ECE/TRANS/WP.11/2007/10  
7 August 2007

Working Party on the Transport of Perishable Foodstuffs

**PROPOSALS OF AMENDMENTS TO THE ATP**

Annex 1, Appendix 2, paragraph 49

## Place and number of temperature sensors

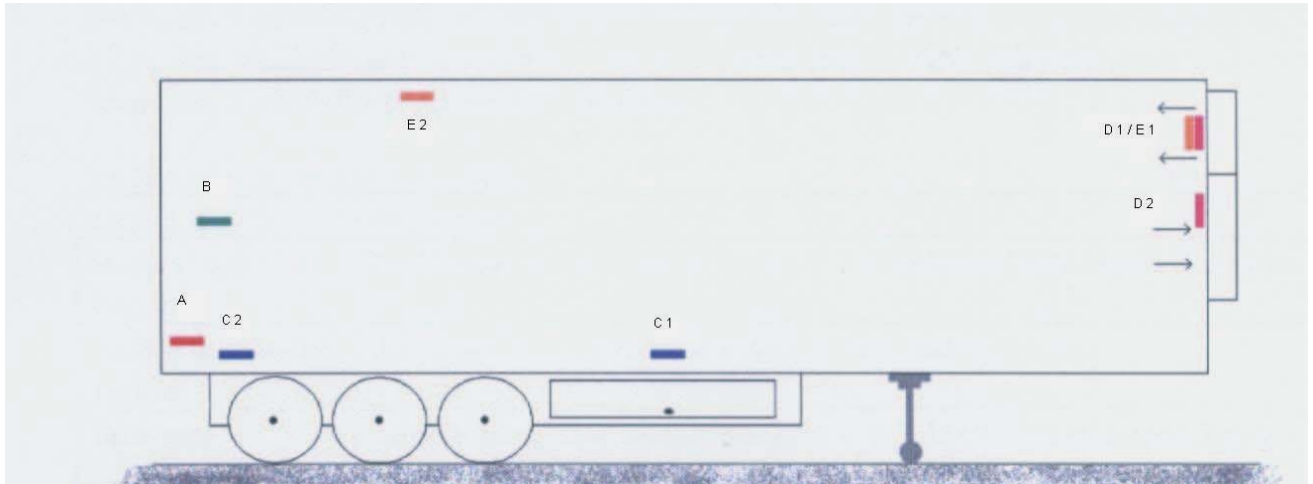
"The outside temperature shall be measured on the centre of one of the sides of the body, 10 cm from the surface. If the test is conducted outside, the side not directly in the sun shall be used. The internal temperature shall be measured at the outlet of the evaporator and at 2/3 distance from the front of the body 10 cm below the top. The temperature of the last temperature sensor to reach the class limit shall be used to determine the test time. The time used by the cooling appliance to defrost the evaporator shall be deducted from the total test time."

8. The position of the temperature sensor at 2/3 distance from the front of the body for in-use testing of the thermal appliance in the Netherlands is based on the place of the sensors for the temperature recorder. In daily use the temperature in this position should be able to be maintained by the cooling appliance for conformity with EC legislation.
